STAFF REPORT: 10/12/2022 REGULAR MEETING PREPARED BY: D. RIEDEN

APPLICATION NUMBER: #22-8059

ADDRESS: 506 PARKVIEW

SCOPE: ERECT WROUGHT IRON FENCE

Fig 1-3, by Applicant: Proposed design of 6' wrought iron fence, driveway gate and pedestrian gates.

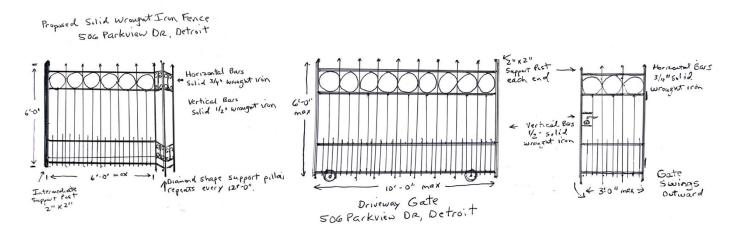
- The Berry Subdivision Historic District was established in 1978.
- Upon receipt of the application, staff requested a sketch of the design of the fence (see figures 1-3 above) and received confirmation that the fence is customdesigned, wrought iron material.

- However, it is also staff's opinion that the fence height along this location should also contribute to the "wall of continuity" and should be no higher than 5 feet above the sidewalk, whether it is placed before or after the grade beam.
- While the fence height is too high at the front yard and the location of the front yard is in conflict with the property line, it is staff's opinion that the fence design and materiality of the proposed fence and gates are appropriate and meet the Elements of Design for Berry Subdivision Historic District.

- The front yard location of the fence and gates extend past the property line.
- It is staff's opinion that the location of the front yard fence is appropriate because it extends the "wall of continuity" on this side of Parkview Street, however the *scale* of the fence height is too high and disrupts the "wall of continuity".
- It is staff's opinion that the fence location at the property line, which would be above the grade beam, and an adjusted maximum height of 5' from the sidewalk would be an appropriate location and scale for this fence.
- The proposed design and materiality of this fence, the mailbox and address numbers are appropriate in staff's opinion.

- The fence line be located at or inside the property line.
- The fence and gates along Parkview measure no higher than 5 feet.
- Staff receive final plan and drawings that show the fence location and height before installation.

Site Plan 1, by Applicant: Proposed location of fence line (in red), showing the front fence and gate locations go outside of the property line (black bold line).

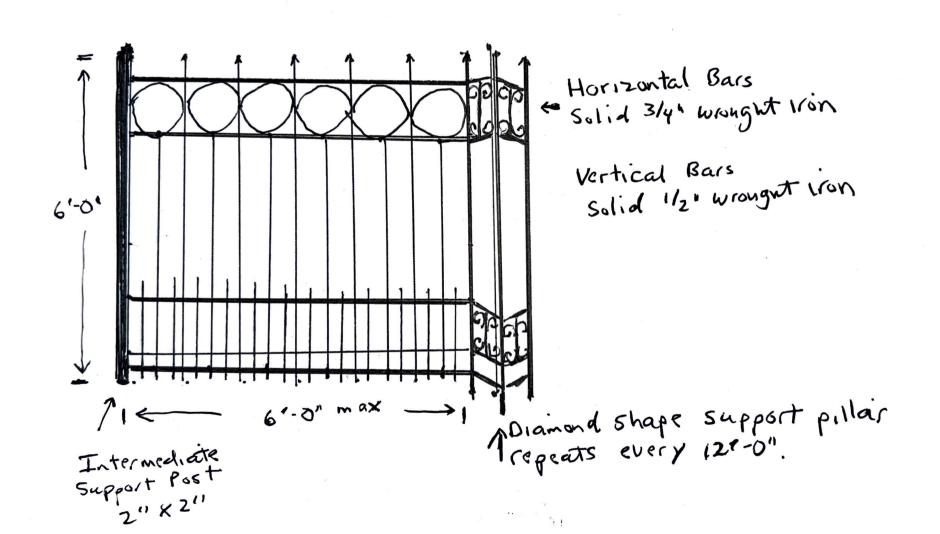
- Staff observed that the proposed fence line exceeds the property line at the front of the house, while it meets the property line on the sides and rear of the house. (See Site Plan 1) Staff received confirmation on the front line of the fence and gates as shown in this plan from the applicant, placing the fence between the grade beams and 6" from the public sidewalk.

- Staff requested the applicant to state why they
 were proposing to place the front edge of the
 fence beyond the front face of the building.
 The applicant stated that they observed other
 properties have done the same and because the
